Project #22-053
Black Rifle Coffee Company
Located at 398 North Main Street

Project Name: Black Rifle Coffee Company
Proponent / Owner: Julianne McGee (Black Rifle) / Logan Main and 4th Pads LLC
Project Address: 398 North Main Street
Request: Design Review Permit
Current Zoning: Town Center 1 (TC-1)
Type of Action: Quasi-Judicial
Date of Hearing: January 26, 2023
Submitted By: Tanya Rice, Planner II

RESUBMITTAL 1/26/23 – Summary of Changes

Figure 1 shows the proposed site plan

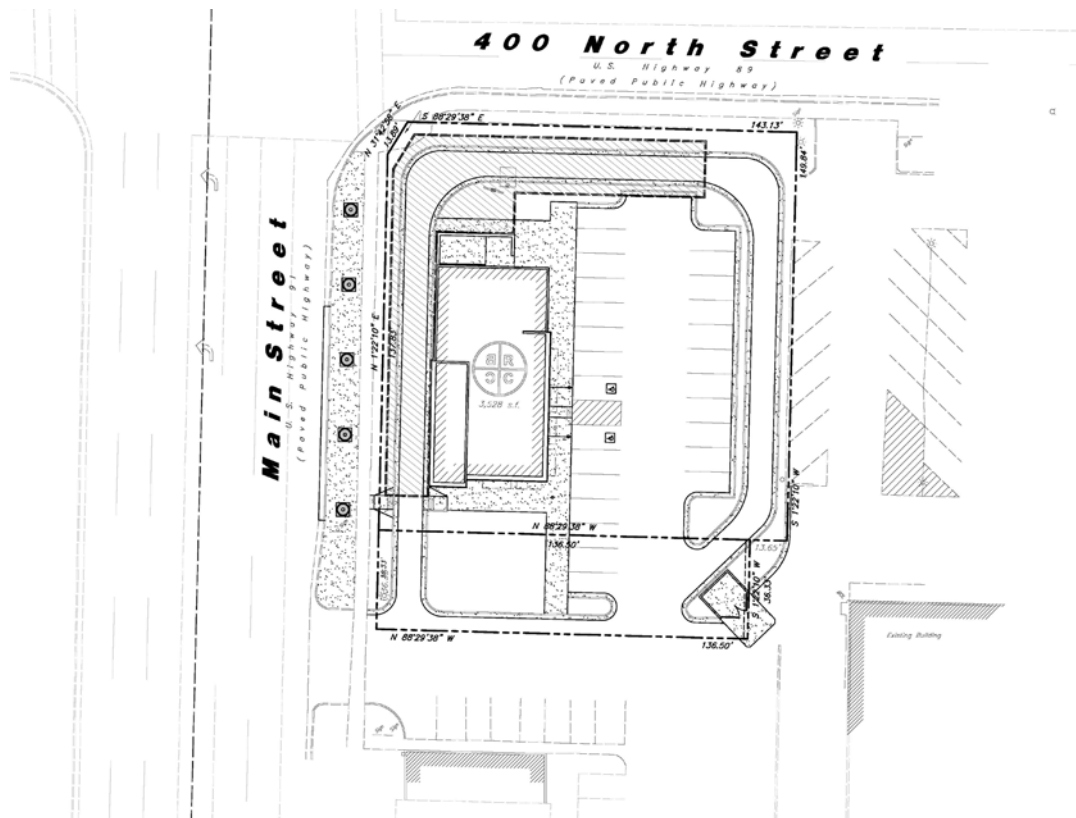
The 0.63-acre project site is located at the southeast corner of the intersection of Main Street and Fourth North is currently vacant and previously contained a gas station and car wash that were removed in 2021. The proposed project includes a new single-story 3,528 SF mixed commercial space (fast food/coffee/retail) covered drive-thru lane along Main Street and 400 North, paved parking lot and landscaping. The proposed drive-thru lane wraps the building & property in a counter-clockwise direction. The primary entrance and paved parking areas are proposed on the east side of the building.

Figure 2 shows the proposed 75% building frontage as seen from 400 N.

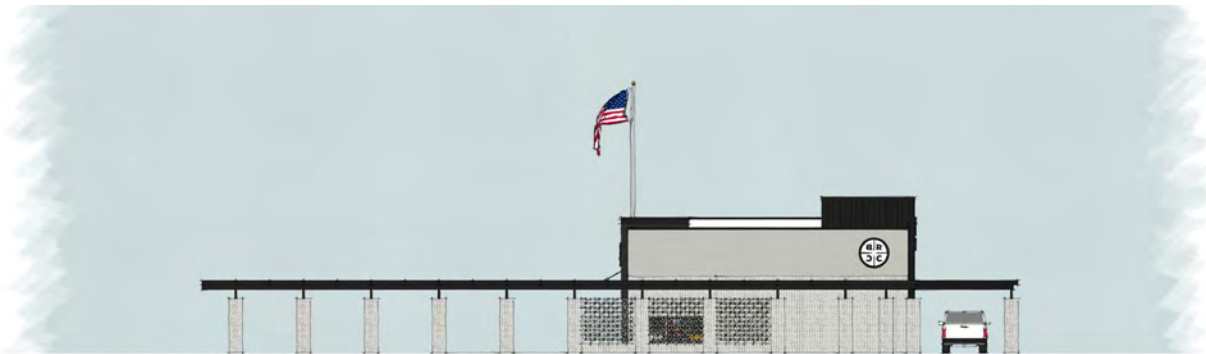
In meeting the standard of building mass along the street frontages, a primary point of consideration is determining whether the proposed design and canopy is considered a "building" as defined by the Land Development Code, and therefore able to be considered in meeting the minimum massing & frontage requirements. According to Chapter 17.62 "Definitions", a building is defined as:

The proposed building design with a main building footprint and canopy extensions are clearly a building as the entire structure contains a roof supported by both walls and columns and is being built for the purpose of persons and property.

A second point of consideration is the actual building itself. Clearly, the applicant's business model for this site is a smaller building housing food/coffee/retail that is taking advantage of a very busy intersection with a high volume of vehicular traffic, and the canopy structure emanating from the primary building footprint is to meet the numerical frontage requirements of the LDC. While the specific frontage percentages are being met, staff's perspective of the overall site & building design is that the scale, asymmetry and length of the drive-thru canopy structures are out of proportion to the building and the focus of the frontage becomes the overhead structure rather than a unified building mass or significant building presence along both streets. The specific comparison that has been discussed is the new In & Out Burger building across 400 North. Their design included covered porticos over the drive thru lanes as a way to extend the building mass out to the sidewalk and streetscape in order to meet the TC-1 frontage and massing requirements. Their design achieved this by incorporating more significant roof lines, more significant pillars, and large architectural features placed over the canopies, all of which provide a sense of building mass next to the sidewalk.

Staff recommends the Planning Commission consider utilizing some design discretion and allow a reduction in canopy length (thereby frontage length) to reduce the length of the overhead drive-thru structure in order to gain a more appropriately scaled and proportioned building along 400 North and direct the applicant to replace the deficient frontage with enhanced landscaped areas.

A third point of consideration is that the proposed site design and building layout falls short in creating a walkable urban design as specific in LDC 17.10.040 Building Form as the overall layout is more conducive to vehicles versus someone walking to, or along, the site. The overall site and building design lacks an important visual connection to the streetscape. These specific points of consideration will be further discussed below.

- 1) All standard conditions of approval will be recorded with the Design Review and are available in the Community Development Department.
- 2) The overall frontage along 400 N may be reduced by ____ so the overhead drive-thru structure may be to better scale, symmetry and balance with the building.

- 3) Enhanced landscaping may be used along 400 N where there is discrepancy in frontage percentage.
- 4) The laser cut metal screening within the drive-thru pillars may be used toward the 60% transparency requirements along street facing facades.
